CRMC DECISION WORKSHEET

**STATE OF RHODE ISLAND AND PROVIDENCE PLANTATIONS
COASTAL RESOURCES MANAGEMENT COUNCIL
STAFF REVIEW**

SUBJ: CRMC File No.: 2018-12-037
 Owner: Jon Janikies
 Site Address: 166 Waterway Drive Plat: N-B Lot: 1
 Site Town: Narragansett
 Project: To c/m a residential boating facility with 30,000lb boat lift and jet ski lift.

Reviewed plans: Ten sheets entitled “Proposed Residential Pier for Jonathan Janikies, 166 Waterway, Narragansett, AP NB, Lot 1, North Kingstown AP 1, Lot 148..” last revised April 2, 2020 by Warren F. Hall, RPE and One Sheet entitled “Plan Showing Mooring Area C...” dated Feb 19, 2021 by same.

Figure 1

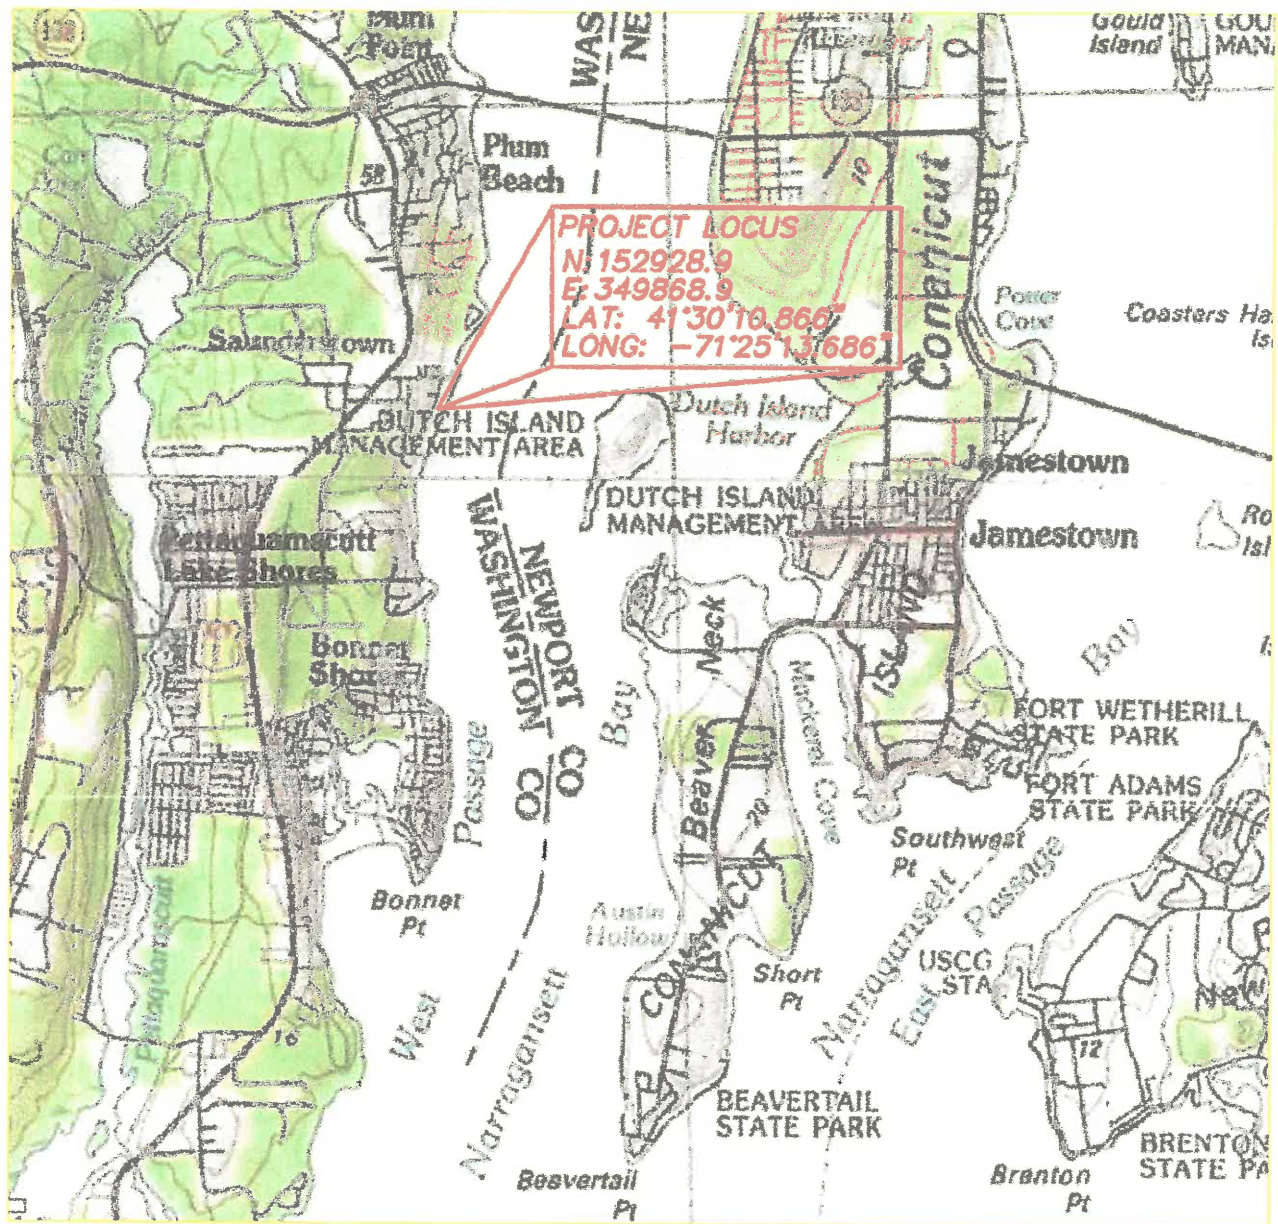
1) The project site is along a residential shoreline in Saunderstown, which is located partially within the Towns of Narragansett and North Kingstown **(Figure 1)*. The facility is proposed along the Narragansett shoreline. Several existing docks are located along this stretch, though none quite the size as the current proposal. The site is comprised of residential development with large lawn leading to a mostly vegetated steep coastal bank. However, pre-existing manmade shoreline components, including concrete deck, revetment and kitchen/patio area also exist on the site. Historically, a previous dock founded from this developed portion of the shoreline but it is long since removed and has no valid CRMC permit. Previous CRMC Enforcement action has been issued regarding various work on the existing wall and developed feature, however the violations were deemed clear by the Executive Director prior and a re-check by CRMC Enforcement in 2019 also deemed no current violations regarding the existing shoreline development.

LEDGE ANCHOR & ROCK SOCKET

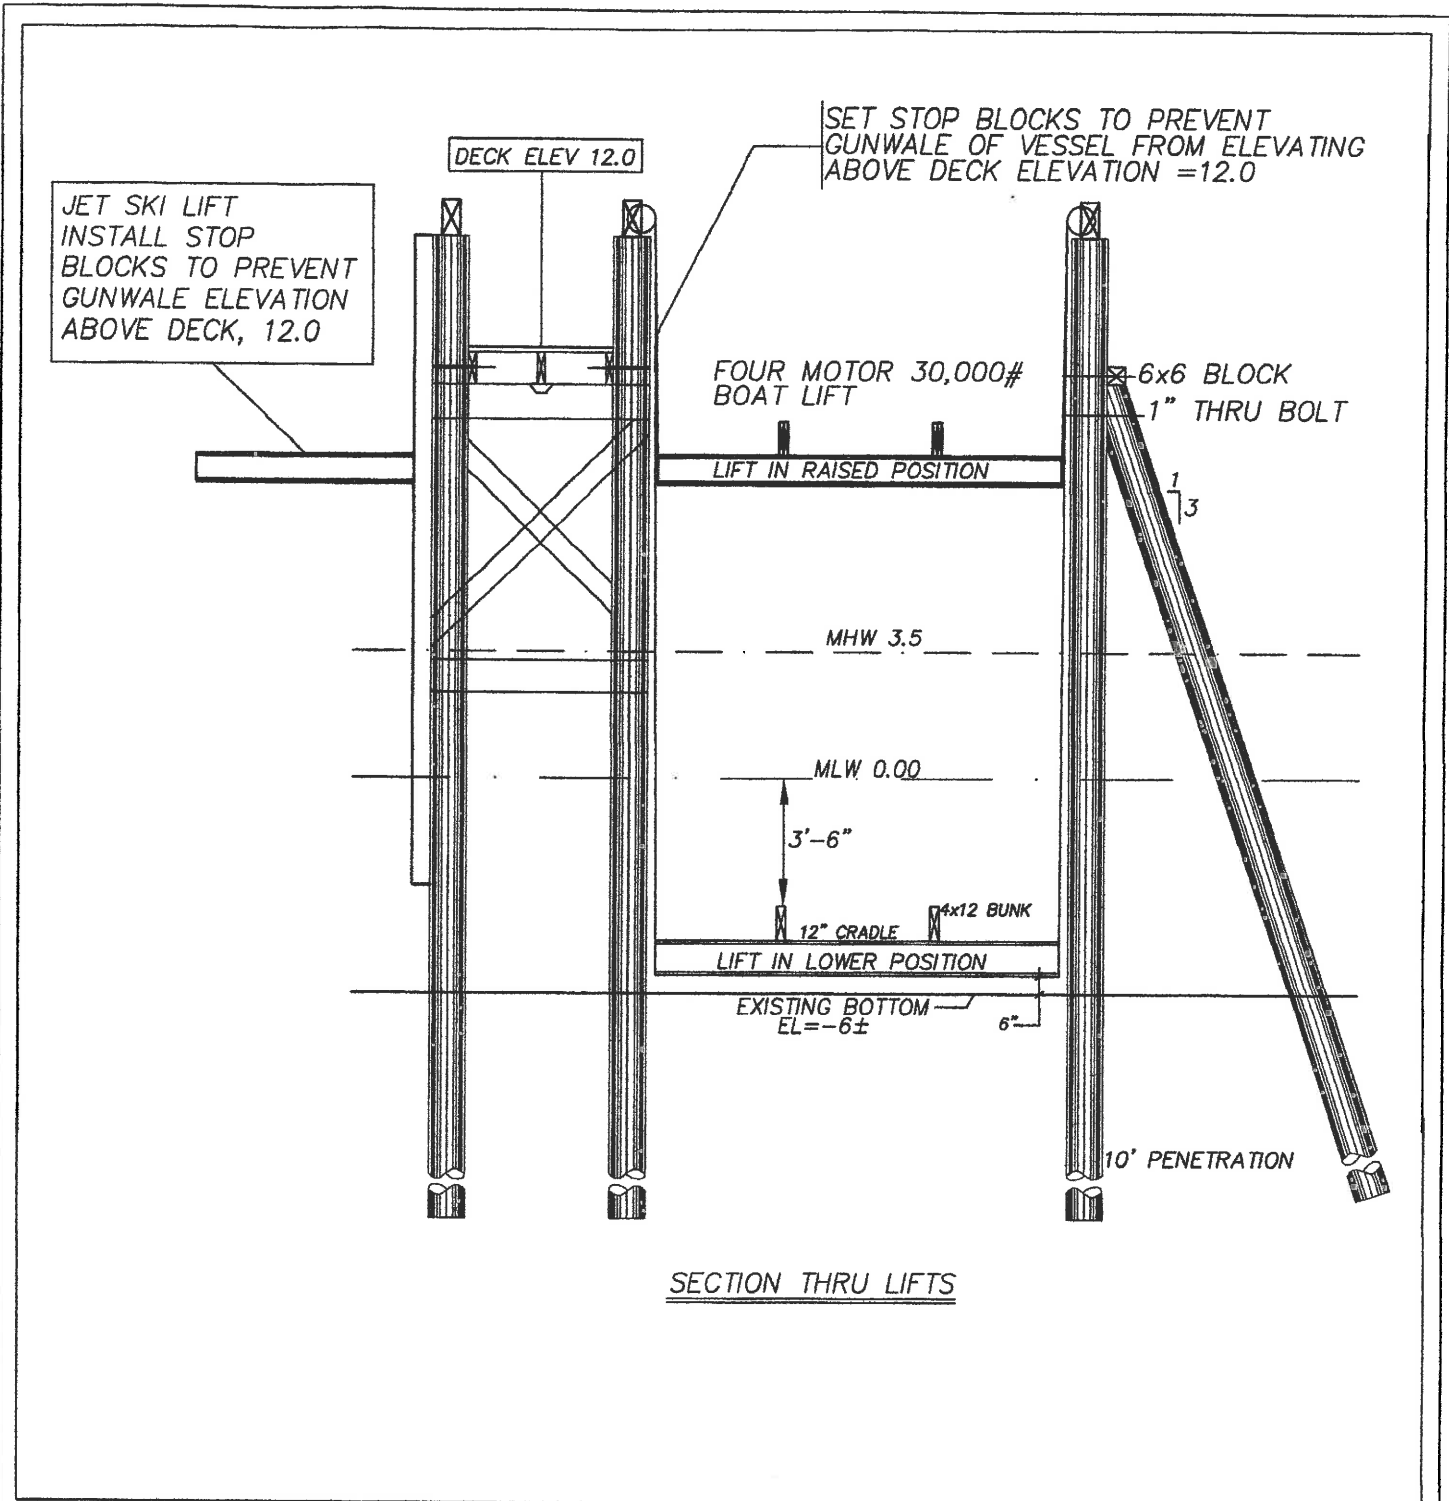
3) The applicant has stated the possible use of ledge anchors and rock sockets may be required due to site conditions. **A variance is therefore required to Section 1.3.1(D)(11)(p) & 1.3.1(D)(11)(r) which require geologic site conditions appropriate for pile driven structural support and limit steel materials.* Ledge anchors and rock sockets have been permitted in similar conditions. Relative to comments received, ledge anchors may be required due to a large rock outcrop located at 71 feet from the beginning of the pier. In addition, pre drilled rock sockets may

be required where barge mounted pile driving is unfeasible due to site conditions. It should be noted that other docks have been constructed in the area with similar geological site conditions.

PLAN SHOWING MOORING AREA C
ADJACENT TO :
PROPOSED RESIDENTIAL PIER FOR:
JONATHAN JANIKIES
166 WATERWAY
NARRAGANSETT AP NB, LOT 1
NORTH KINGSTOWN, AP 1, LOT 148
BY: WARREN HALL, CIVIL ENGINEER
FEB 19, 2021 SHEET 1 OF 1

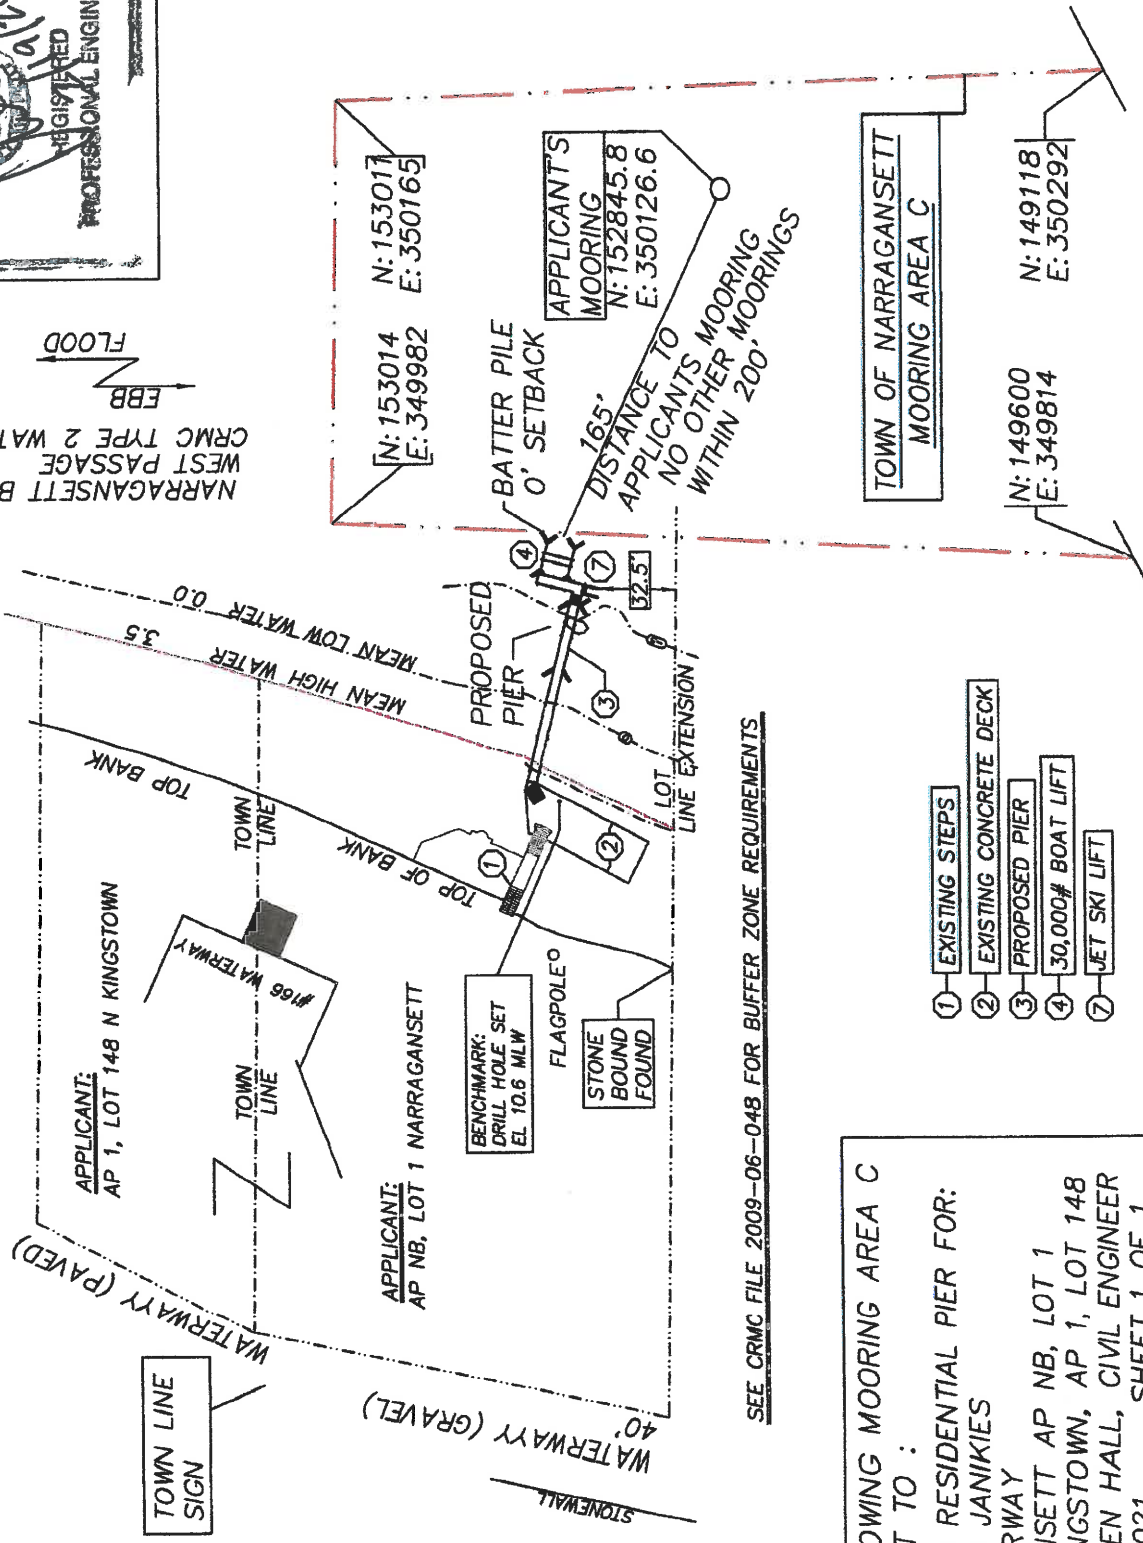
4) A variance is also required to RICRMP Section 1.3.1(D)(11)(m) which states that docks piers and floats shall be set back at least 50 feet from an approved mooring field. The Town of Narragansett Mooring Area C is located exactly at the terminus of the proposed facility. There is only one mooring in the area, owned by the applicant, located 165 feet from the proposed facility. The Narragansett Harbor Management Commission met on May 5, 2020, and approved the boating facility 6-0 without discussion. It will be recommended through CRMC policy staff that the Harbor Commission make appropriate revisions to Mooring area C if this project is approved by the Council, however past CRMC practice is to consider a Town signoff on a mooring issue as support for the setback variance.
